Engine Noise

Bulletin No.: 67-61-14B

Engine Noise (Install Valve Stem Oil Seal)

Figure 1**Legend**

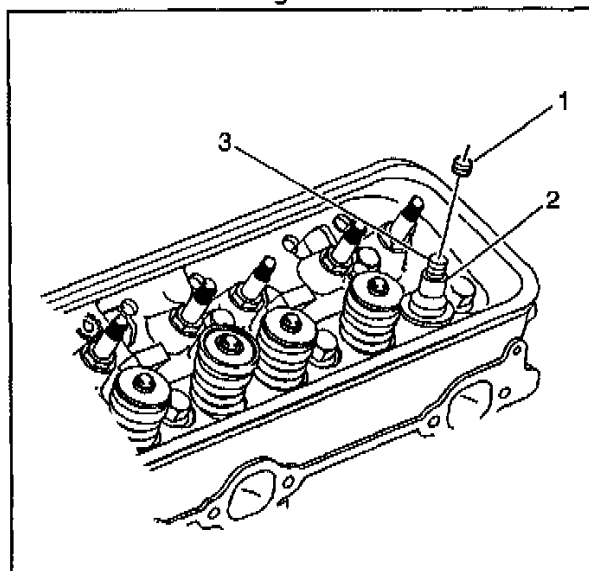
The noise may be caused by a low level of lubrication on the exhaust valve stem, creating a "slip-stick" condition between the valve stem and valve guide.

Install the valve stem oil seal listed below, ON THE EXHAUST VALVE GUIDES ONLY.

Lightly lubricate the seal, and with finger pressure only, push it on to the valve stem and down on to the exhaust valve guide. (See Figure 1)

DO NOT install this seal on intake valve guides. This seal is NOT released for intake valve application in the above identified vehicles.
